# Access Compliance Report

## Public Rights-of-Way

Intersection ID: 48955	Main Street: ROYA_PL	Cross Street: DAVID_JENNINGS_AV	Location:	N
ADA ID: A70AD8CBCCA7	Ramp Type: Perp	Initial Pass/Fail: Fail	Overall Compliance: No	Severity Score: 10

#### Codes/Mitigation Info/Possible Solution

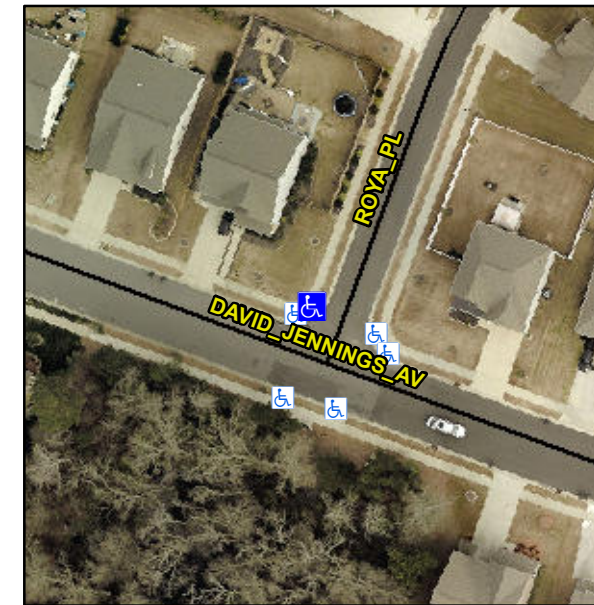
**Not Found, R304.5.1, R304.5.3**

Compliance	Description	Data	Compliance	Description	Data
N/A	Ramp Length (in)	49.0	Yes	Ramp Slope (%)	5.3
No	Ramp Width (in)	47.0	No	Ramp XSlope (%)	2.5
N/A	Flare Type LT	N/A	N/A	Flare Type RT	N/A
N/A	Flare Slope LT (%)	N/A	N/A	Flare Slope RT (%)	N/A
N/A	Flare Traversable LT?	N/A	N/A	Flare Traversable RT?	N/A
N/A	Landing Length (in)	N/A	N/A	DWS Provided?	N/A
N/A	Landing Width (in)	N/A	N/A	DWS Contrast?	N/A
N/A	Landing Slope (%)	N/A	N/A	DWS Length (in)	N/A
N/A	Landing X Slope (%)	N/A	N/A	DWS Full Width?	N/A
N/A	Landing Curb? (Y/N)	N/A	N/A	DWS Offset (in)	N/A
N/A	Shared Landing?	N/A			
N/A	Gutter Ponding?	N/A	N/A	Gutter Slope (%)	N/A
N/A	Gutter Lip Ht (in)	1.0	N/A	Gutter X Slope (%)	N/A
N/A	Painted X Walk1?	No	N/A	Painted X Walk2?	N/A
	X Walk 1 Direction	To SE		X Walk 2 Direction	N/A
N/A	X Walk 1 Width (in)	N/A	N/A	X Walk 2 Width (in)	N/A
	X Walk 1 Slope (%)	0.3		X Walk 2 Slope (%)	N/A
	X Walk 1 X Slope (%)	3.0		X Walk 2 X Slope (%)	N/A

**Remove & Replace Entire Ramp.**
